AURIX™ TC23x errata sheet

Marking/Step: ES-AC, AC

About this document

Figure 3 Message RAM configurations

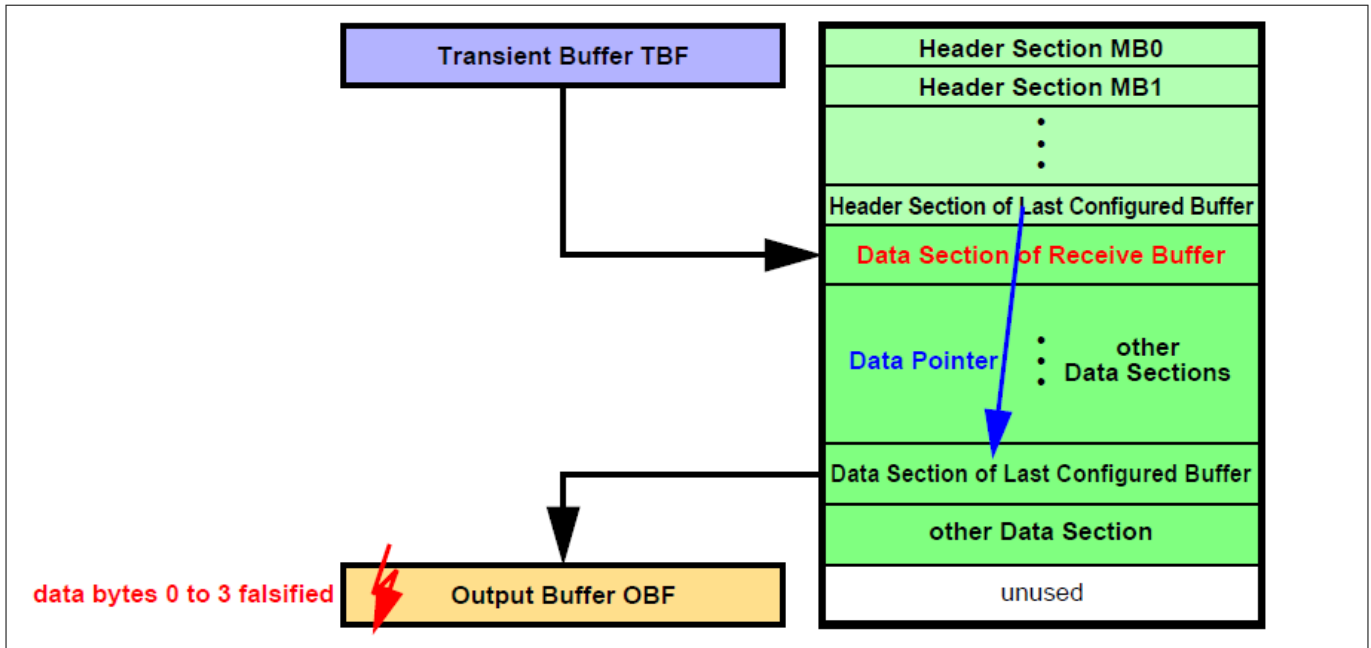
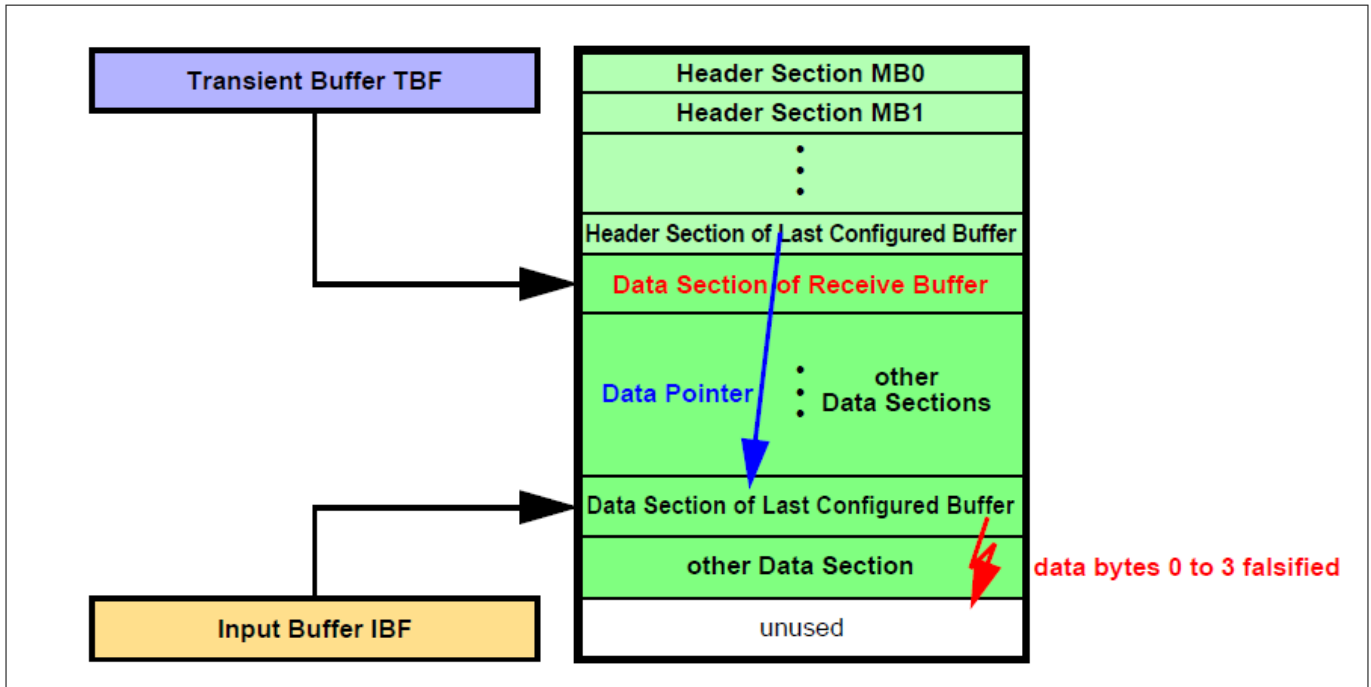
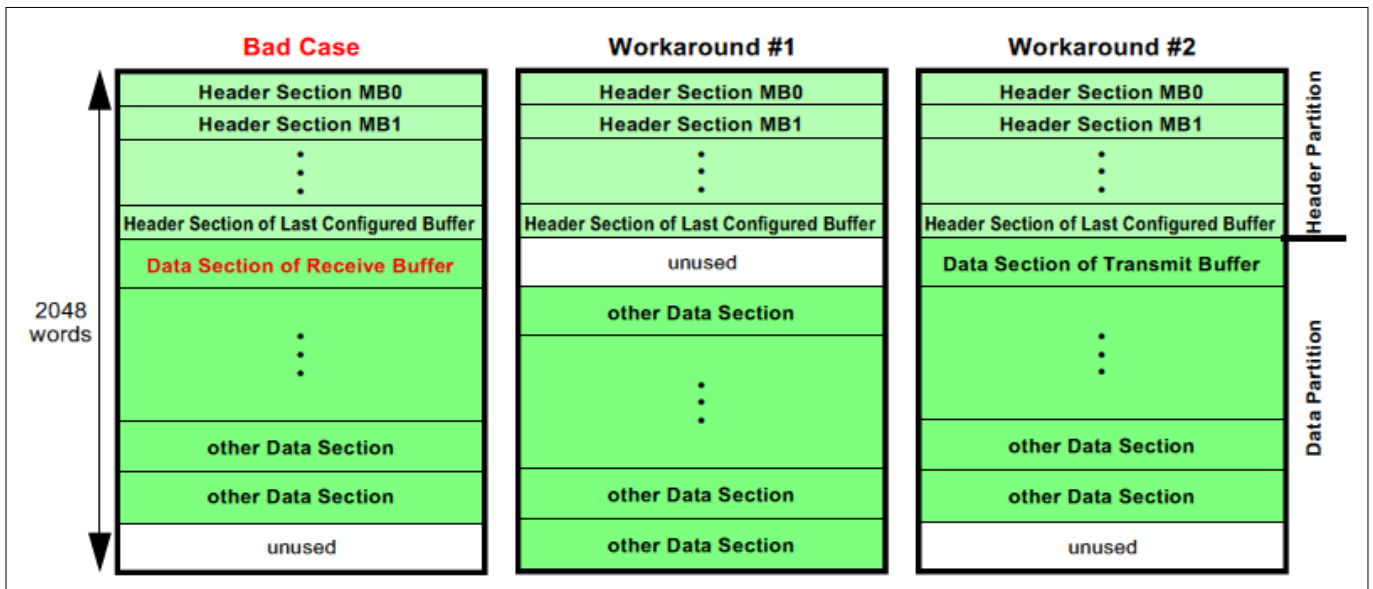
When the message buffer has its payload configured to maximum length (`PLC = 127`), the OBF word on address `00h` (payload data bytes 0 to 3) is overwritten with unexpected data at the end of the transfer.

After the Data Section of the selected message buffer in the Message RAM has been written, one additional write access overwrites the following word in the Message RAM which might be the first word of the next Data Section.

- a) When a message is transferred from the Last Configured Buffer in the Message RAM to the OBF and PLC = 127 it may happen, that at the end of the transfer the OBF word on address 00h (payload data bytes 0 to 3) is overwritten with unexpected data (see [Figure 1](#))
- b) When a message is transferred from IBF to the Last Configured Buffer in the Message RAM, it may happen, that at the end of the transfer of the Data Section one additional write access overwrites the following word, which may be the first word of another message's Data Section in the Message RAM (see [Figure 2](#))

Workaround 2

Ensure that the Data Section directly following the Header Partition is assigned to a transmit buffer.

Figure 4 Transmitter - winning CAN FD node

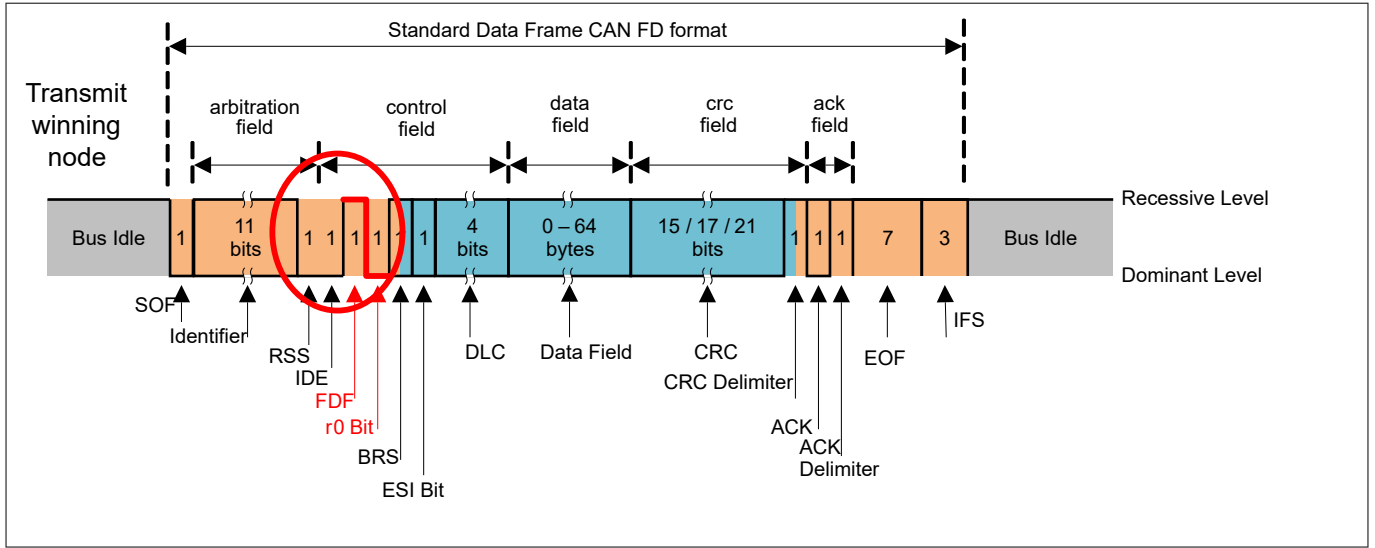
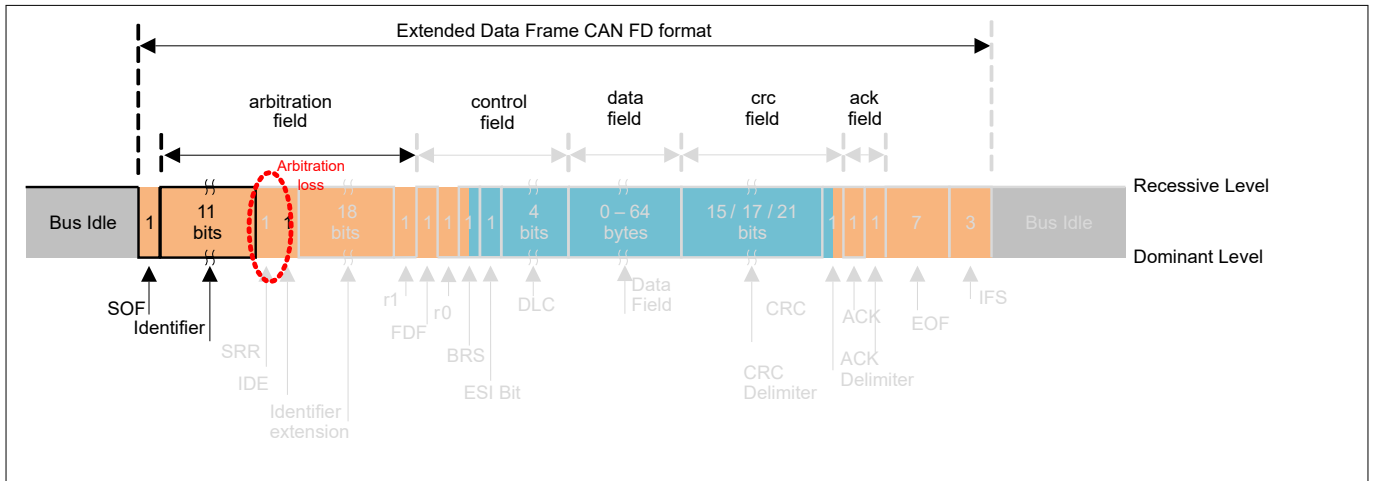
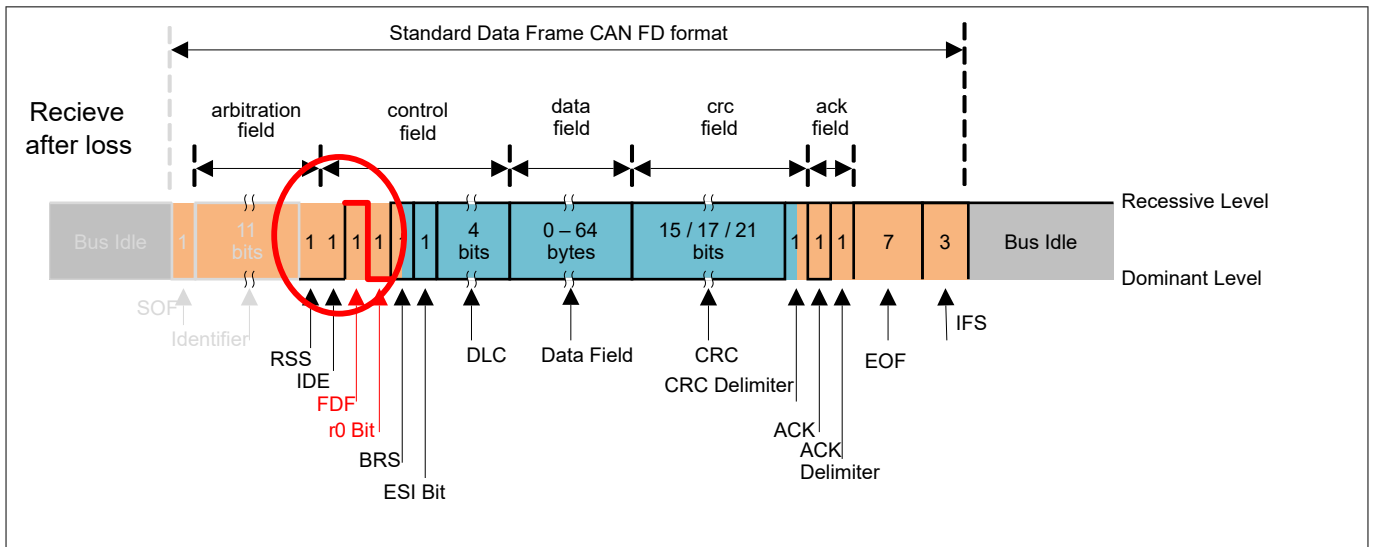
If a transmitter is losing arbitration late (for example in an extended frame - see [Figure 4](#) the node which wins arbitration and [Figure 5](#) the transmitting node losing arbitration), then the FDF bit to res bit is the last chance to synchronize to the winning node (here as a receiver [Figure 6](#) the same node as in [Figure 5](#)). A timing offset will occur between the now receiving node and the actual transmitter.

The device is producing more error frames within a network than a device with a hardsync at the FDF bit.

Figure 12 Package Outlines TQFP-144 for TC23x

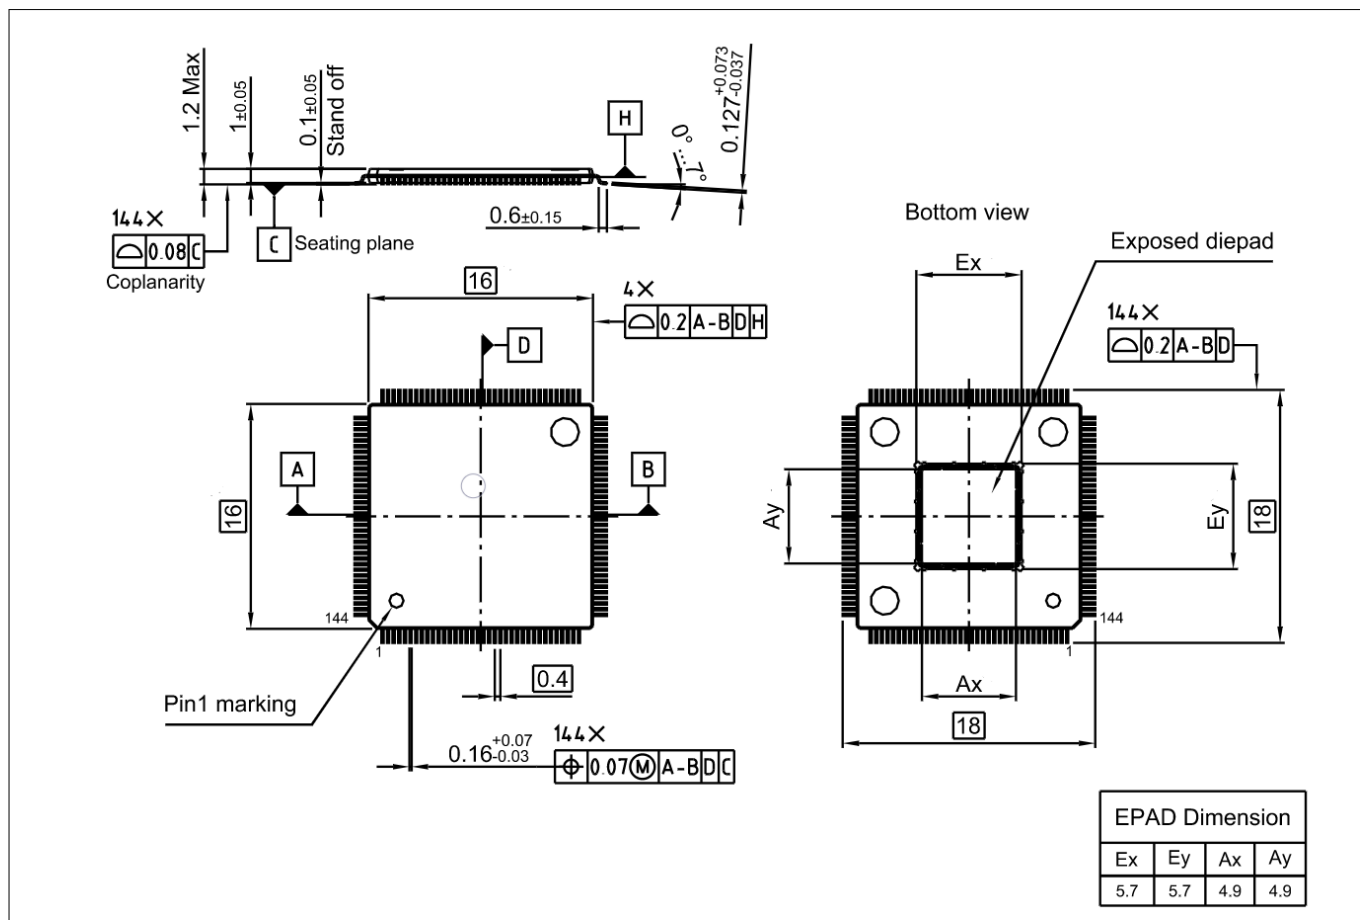
Note: For the exposed pad of the TQFP-144 package of the TC23x, structural corner protrusions have to be considered for purposes of system design and integration with a maximum boundary of 6.2 mm.

Figure 13 Package Outlines TQFP-100 for TC23x

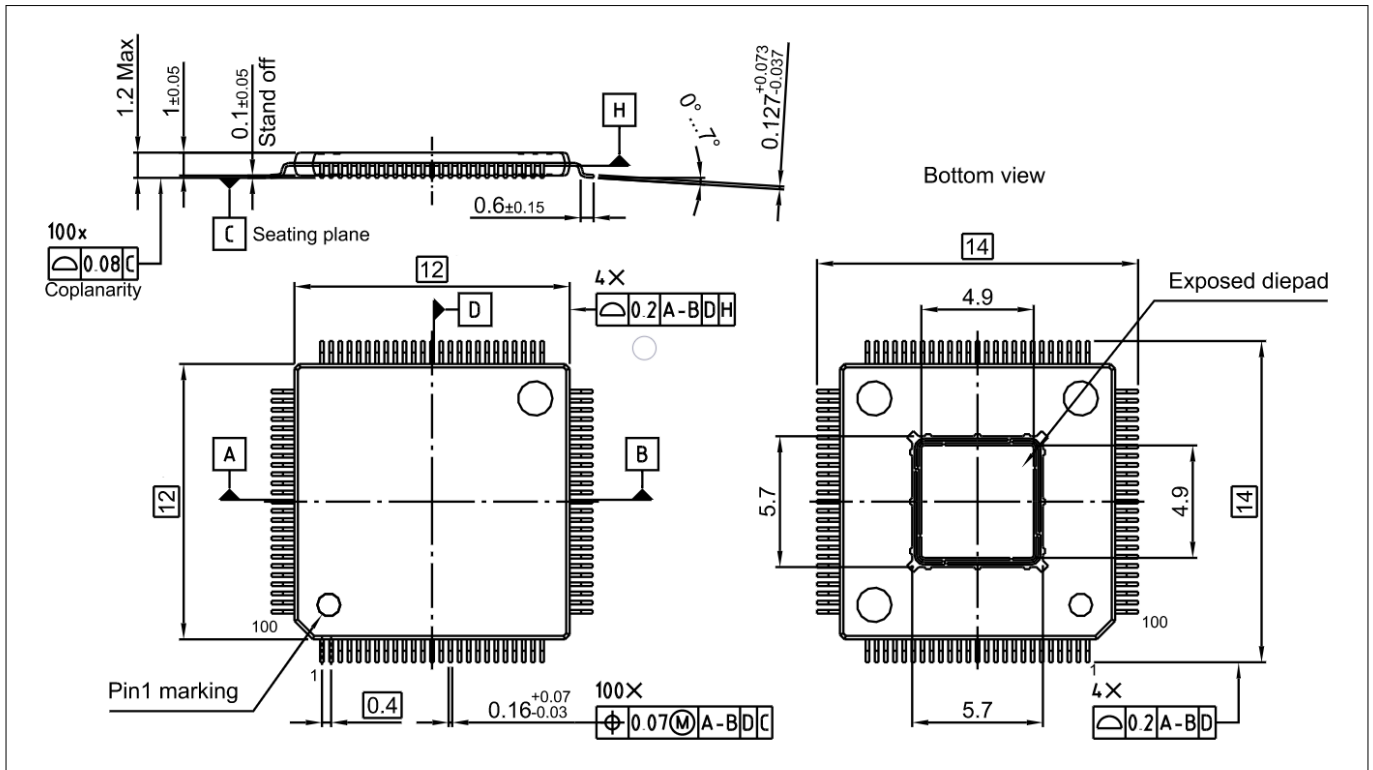
Note: For the exposed pad of the TQFP-100 package of the TC23x, structural corner protrusions have to be considered for purposes of system design and integration with a maximum boundary of 6.3 mm.

Figure 15 Short Serial Message, Serial Data Encoding over 16 messages

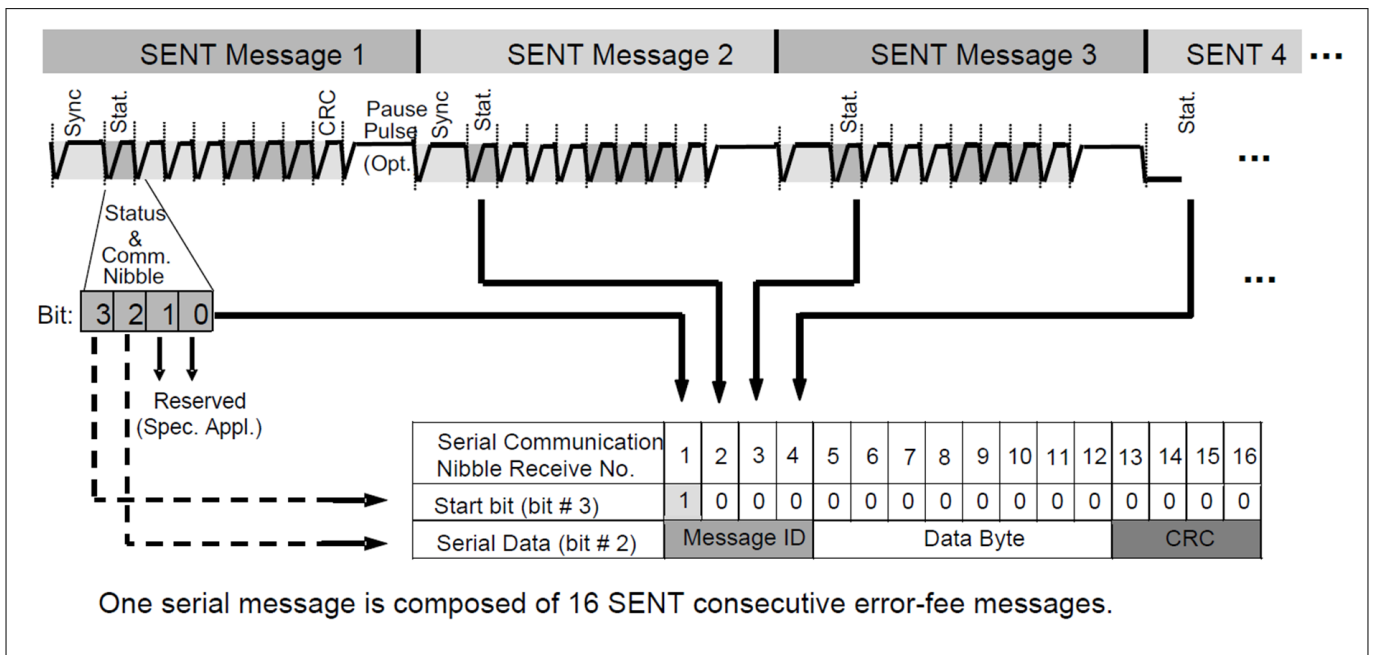
Correction

Figure 15 shows a corrected version of this figure.
